# Access Compliance Report

## Public Rights-of-Way

Intersection ID: 2768	Main Street: BELL'S_MILL_DR	Cross Street: CRAIL_CT	Location: SE
ADA ID: 3645E22DD4BF	Ramp Type: BlendTrans1	Initial Pass/Fail: Pass	Overall Compliance: No
		Severity Score: 10

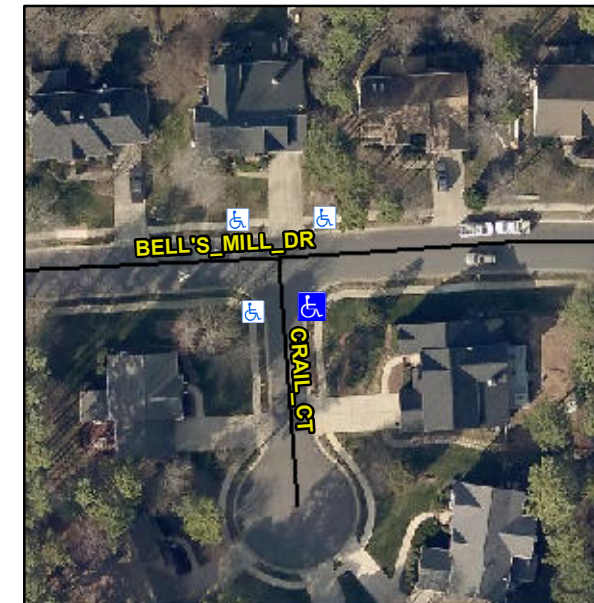
**Not Found, R304.2.1, R304.2.2-Perp, R304.3.2-Para, R305**

Compliance	Description	Data	Compliance	Description	Data
N/A	Ramp Length (in)	47.0	Yes	BlendTrans Slope (%)	1.9
Yes	Ramp Width (in)	120.0	Yes	BlendTrans XSlope (%)	1.4
N/A	Flare Type LT	Sloped	N/A	Flare Type RT	Sloped
N/A	Flare Slope LT (%)	0.5	N/A	Flare Slope RT (%)	3.7
N/A	Flare Traversable LT?	No	N/A	Flare Traversable RT?	No
No	Landing Length (in)	47.0	No	DWS Provided?	No
Yes	Landing Width (in)	120.0	N/A	DWS Contrast?	No
No	Landing Slope (%)	2.8	N/A	DWS Length (in)	N/A
Yes	Landing X Slope (%)	1.5	N/A	DWS Full Width?	No
N/A	Landing Curb? (Y/N)	No	N/A	DWS Offset (in)	N/A
N/A	Shared Landing?	No			
Yes	Gutter Ponding?	No	Yes	Gutter Slope (%)	3.2
Yes	Gutter Lip Ht (in)	0.0	Yes	Gutter X Slope (%)	1.8
N/A	Painted X Walk1?	No	N/A	Painted X Walk2?	No
	X Walk 1 Direction	To N		X Walk 2 Direction	To W
	X Walk 1 Width (in)	N/A		X Walk 2 Width (in)	N/A
	X Walk 1 Slope (%)	2.1		X Walk 2 Slope (%)	5.3
	X Walk 1 X Slope (%)	3.9		X Walk 2 X Slope (%)	0.7

N/A	Ramp inside XWalk1?	N/A	N/A	Ramp inside XWalk2?	N/A
	Road Slope (%)	3.1		Clear Space?	Yes
	Road X Slope (%)	4.4	N/A	Clear Space to XWalk (in)	N/A
Yes	Any Obstructions?	No	Yes	Storm Grate/Utility Hazard?	No
	Obstruction Type			Storm Grate/Utility Type	
		N/A			N/A
			Yes	Surface Condition? (G/P)	Good
			No	Curb Slope (%)	5.6

**Remove & Replace Curb Ramp With Two New Directional Ramps or Equivalent.**
